Austausch des Abluftstutzens aus Metall gegen eine geänderte Version aus Kunststoff

Betrifft Modell: MWGD 750.0

Replacing the metal air vent with a modified plastic version Concerns model: MWGD 750.0

Abluftstutzen neu ET-Nr. 545885.

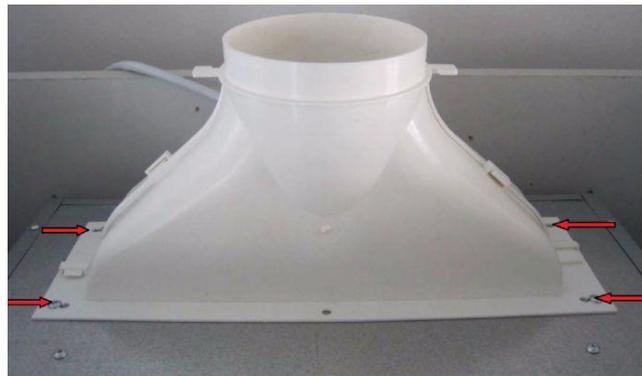
Fehlerbild:

Bei Änderung der Leistungsstufen erfolgt keine Änderung der Motordrehzahl. Das Laufgeräusch bleibt auch bei Änderung der Leistungsstufe immer gleich. Die Saugleistung ist ungenügend.

Achtung!

Der neue Abluftstutzen ist um 96mm höher als der alte. Abhängig von der Abluftführung ist deshalb die Montage des geänderten Stutzens nicht immer möglich.

Error pattern:

The motor speed does not change when the power levels are changed. The noise made during operation stays the same, even when the power level is changed. The suction power is not strong enough.

Important!

The new air vent is around 96mm taller than the old one. It is thus not always possible to install the modified air vent; this depends on the outgoing air duct.

Der Abluftstutzen aus Kunststoff wird mit vier Schrauben befestigt.

The plastic air vent is secured with four screws
